ADDENDUM NO. 1

ALEXANDER CITY MUNICIPAL COMPLEX
ALEXANDER CITY, ALABAMA

This Addendum No. 1, to the plans and specifications, dated August 8, 2019, consists of Eighteen (18) Pages.

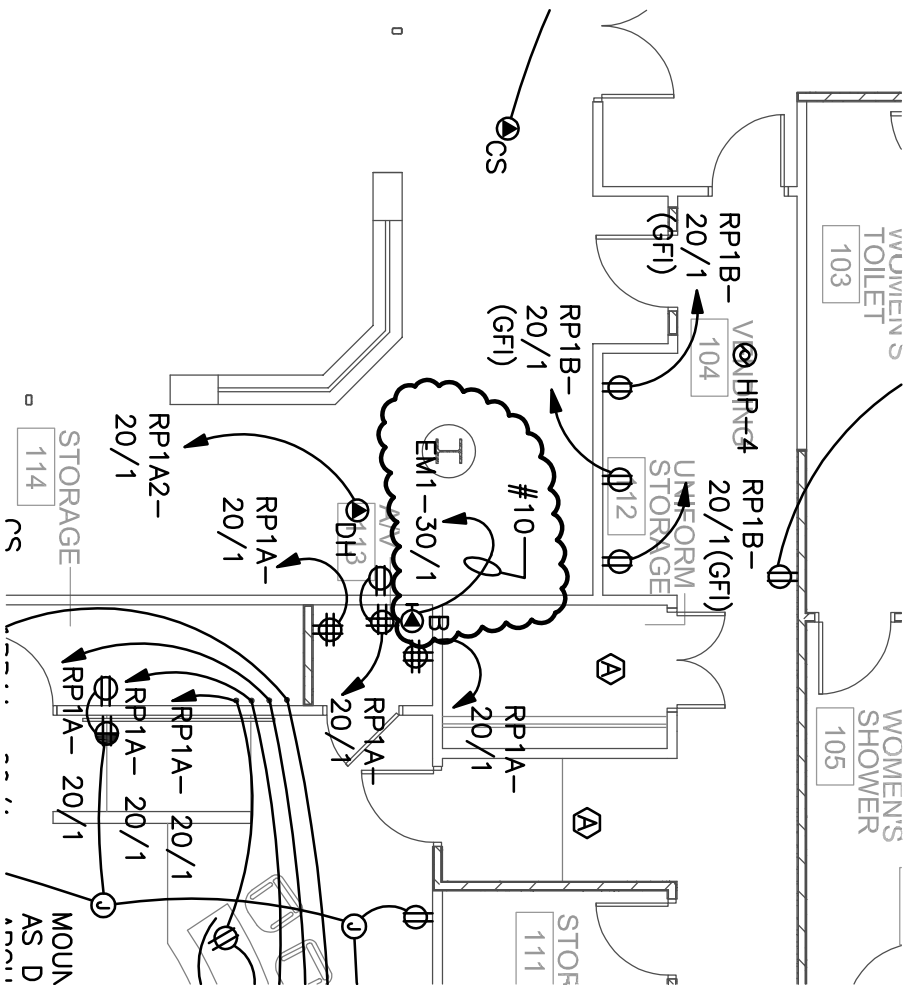
Item No. 6: Refer to Plans, Sheet E2, Schedules and Details:

- A. Change clouded items as shown on ESD-1 included in this addendum.

BREAKER SCHEDULE

BREAKERS TO BE INSTALLED

ESD-2
 AUGUST 30, 2019
 CHANGES TO SHEET E6
 LOWER FLOOR POWER
 PLAN

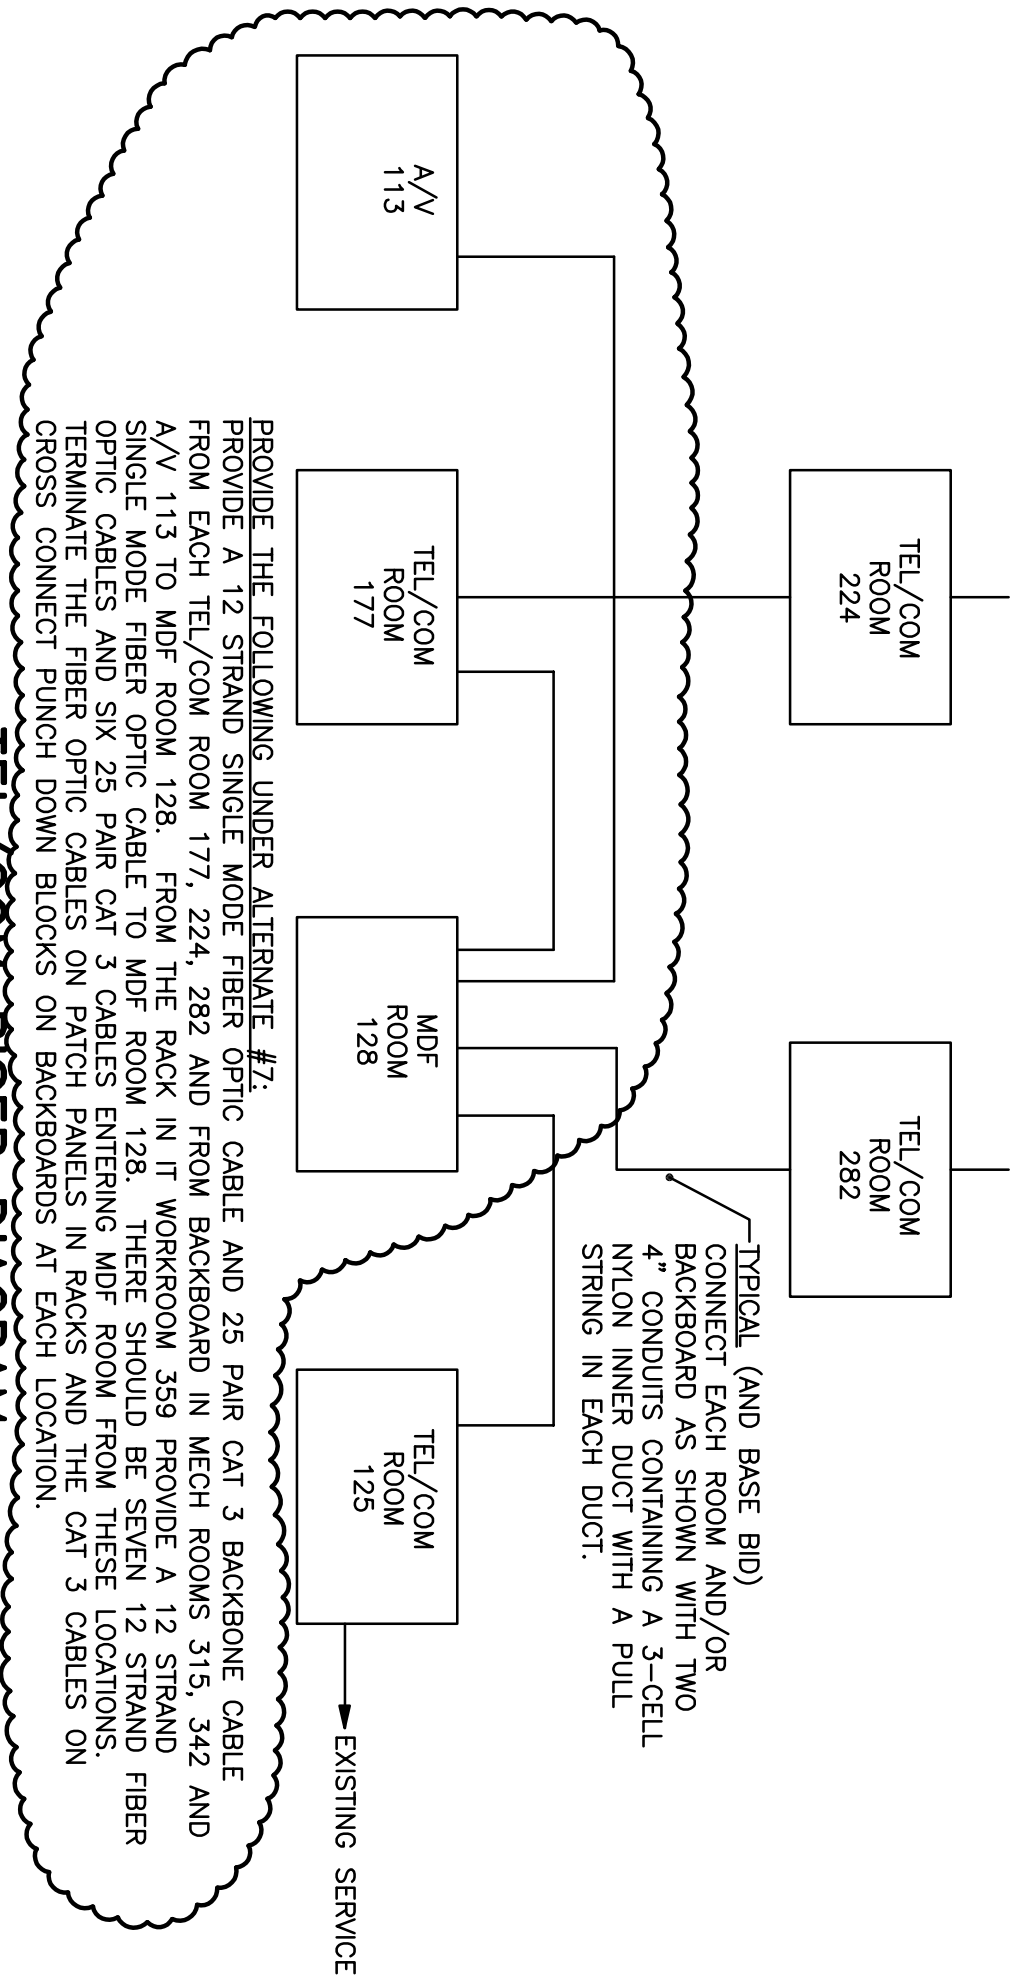
Item No. 7: Refer to Plans, Sheet E6, Lower Floor Power Plan:

A. Change clouded area as shown on ESD-2 included in this addendum.

PROVIDE THE FOLLOWING UNDER ALTERNATE #7:
 PROVIDE A 12 STRAND SINGLE MODE FIBER OPTIC CABLE AND 25 PAIR CAT 3 BACKBONE CABLE FROM EACH TEL/COM ROOM 177, 224, 282 AND FROM BACKBOARD IN MECH ROOMS 315, 342 AND A/V 113 TO MDF ROOM 128. FROM THE RACK IN IT WORKROOM 359 PROVIDE A 12 STRAND SINGLE MODE FIBER OPTIC CABLE TO MDF ROOM 128. THERE SHOULD BE SEVEN 12 STRAND FIBER OPTIC CABLES AND SIX 25 PAIR CAT 3 CABLES ENTERING MDF ROOM FROM THESE LOCATIONS. TERMINATE THE FIBER OPTIC CABLES ON PATCH PANELS IN RACKS AND THE CAT 3 CABLES ON CROSS CONNECT PUNCH DOWN BLOCKS ON BACKBOARDS AT EACH LOCATION.

TYPICAL (AND BASE BID)
 CONNECT EACH ROOM AND/OR BACKBOARD AS SHOWN WITH TWO 4" CONDUITS CONTAINING A 3-CELL NYLON INNER DUCT WITH A PULL STRING IN EACH DUCT.

ESD--3

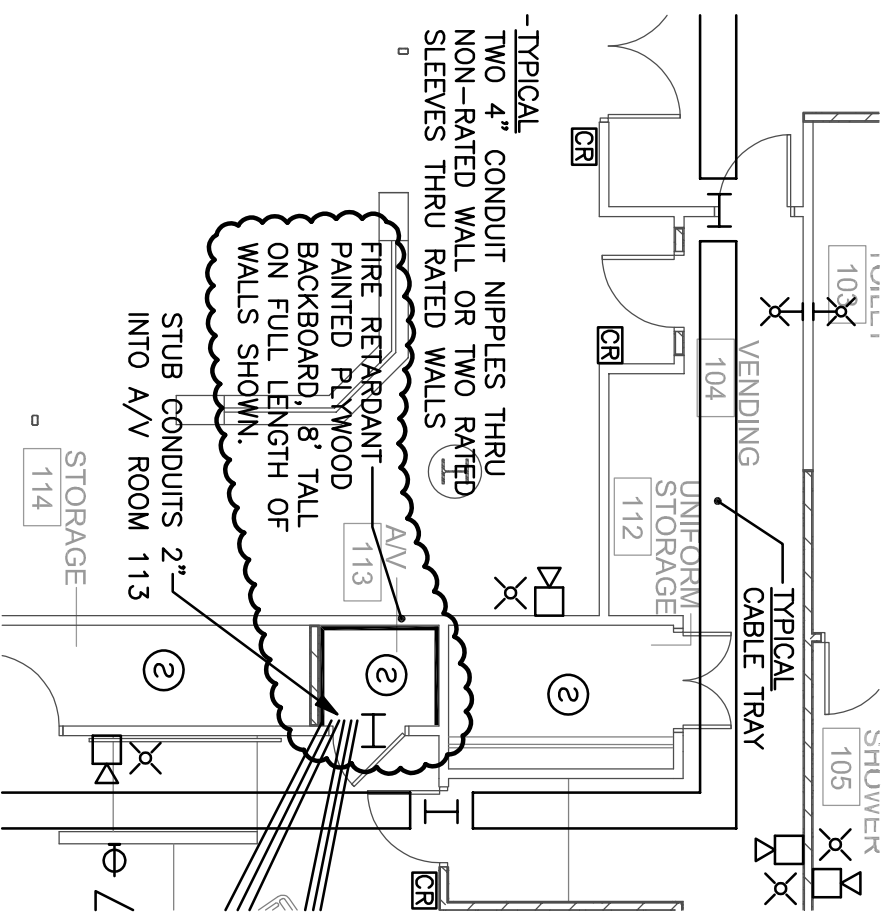
Item No. 8: Refer to Plans, Sheet E9, Lower Floor Auxiliary Systems Plan:

A. Change clouded areas as shown on ESD-3, ESD-4, ESD-5 included in this addendum.

AUXILIARY SYSTEMS NOTES:

1. IN BASE BID RUN FROM EACH TELEPHONE/DATA WALL OUTLET A 3/4" CONDUIT UP IN WALL (UNLESS NOTED OTHERWISE) AND STUB OUT AT AN ACCESSIBLE SPACE ABOVE THE CEILING. UNDER ALTERNATE #7 PROVIDE TWO (OR NUMBER INDICATED BY NUMBER SHOWN ADJACENT TO THE OUTLET) CAT 6 RJ45 JACKS IN THE OUTLET AS DETAILED AND A CAT 6 CABLE FROM EACH JACK AND RUN IN CONDUIT UP WALL TO PATCH PANEL IN RACK IN NEAREST TEL/DATA OR A/V OR MECHANICAL ROOM.

2. IN BASE BID RUN FROM EACH FLOOR OUTLET A CONDUIT AS NOTED FROM THE AUXILIARY SIDE OF BOX ABOVE THE CEILING OF THE FLOOR BELOW (OR BELOW THE SLAB IF ON LOWER LEVEL), UP THRU THE FLOOR, IN THE WALL AND TERMINATE AT WALL OUTLET INDICATED. UNDER ALTERNATE #7 PROVIDE TWO CAT 6 RJ45 JACKS IN THE FLOOR OUTLET (UNLESS NOTED OTHERWISE) SIMILAR TO THAT DETAILED AND A CAT 6 CABLE FROM EACH JACK AND RUN IN CONDUIT THRU WALL OUTLET TO PATCH PANEL IN NEAREST TEL/DATA OR A/V OR MECHANICAL ROOM.

3. IN BASE BID RUN FROM EACH TV WALL OUTLET A 3/4" CONDUIT UP IN WALL AND STUB OUT AT AN ACCESSIBLE SPACE ABOVE THE CEILING. UNDER ALTERNATE #7 PROVIDE TWO COAX RG6 CABLES AND TWO CAT 6 DATA CABLES TO EACH TV OUTLET. RUN CABLES IN CONDUIT UP WALL AND CONCEALED ABOVE THE CEILING. TERMINATE CABLES WITH FEMALE COAX JACKS AND RJ45 JACKS IN COMMON STAINLESS STEEL FACE PLATE. DATA CABLES SHALL HOMERUN TO PATCH PANEL IN NEAREST TEL/DATA OR A/V OR MECHANICAL ROOM AND COAX CABLES SHALL RUN DOWN ON BACKBOARD OF TEL/DATA OR A/V OR MECHANICAL ROOM AND COIL WITH 20' OF SLACK.

4. PROVIDE COLORED JACKS AND CABLES AS FOLLOWS: WHERE TWO CABLES ARE RUN TO AN OUTLET, ONE SHALL BE BLUE FOR VOICE AND ONE SHALL BE YELLOW FOR DATA. WHERE MORE THAN TWO CABLES ARE INDICATED, CONTACT ALEX CITY IT DEPARTMENT FOR NUMBER OF EACH COLOR REQUIRED TO THE OUTLET. THE JACKS SHALL BE SAME COLOR AS THE CABLE. ALL VOICE CABLES SHALL TERMINATE ON SAME PATCH PANEL AND DATA CABLES ON A SEPARATE PATCH PANEL. PROVIDE NUMBER OF PATCH PANELS TO ACCEPT THE CABLES RUN TO IT PLUS CAPACITY FOR 20% MORE CABLES.

5. A CABLE TRAY SYSTEM IS SHOWN ON THE PLANS, BUT IS NOT REQUIRED (EXCEPT IN DISPATCH AND MDF) IF CABLES ARE SUPPORTED BY A CABLE HOOK SYSTEM APPROVED BY THE ENGINEER AND THE ALEX CITY IT DEPARTMENT. IT IS RECOMMENDED TO SUBMIT THE PROPOSED CABLE HOOK SYSTEM AT LEAST TEN (10) DAYS PRIOR TO BID FOR APPROVAL. DATA CABLES SHALL BE SUPPORTED AT INTERVALS NOT EXCEEDING 4'-0" ON CENTER WHEN NOT IN CONDUIT. CAT 6 DATA CABLES SHALL BE TERMINATED AT BOTH ENDS AND TESTED. TERMINATIONS SHALL BE ON FEMALE JACKS AT OUTLETS AND THE OTHER END ON A PATCH PANEL.

6. UNDER ALTERNATE #7 THE CONTRACTOR SHALL FURNISH THE PATCH PANELS AS DETAILED ON THIS SHEET AND AS REQUIRED TO TERMINATE ALL CABLES TO THAT LOCATION. THE OWNER WILL PROVIDE THE RACK. THE CONTRACTOR SHALL INSTALL THE RACKS PER INSTALLATION INSTRUCTIONS AT LOCATIONS DIRECTED BY THE OWNER. THE CONTRACTOR SHALL INSTALL THE PATCH PANELS IN OWNER'S RACK IN LOCATIONS DIRECTED BY THE OWNER.
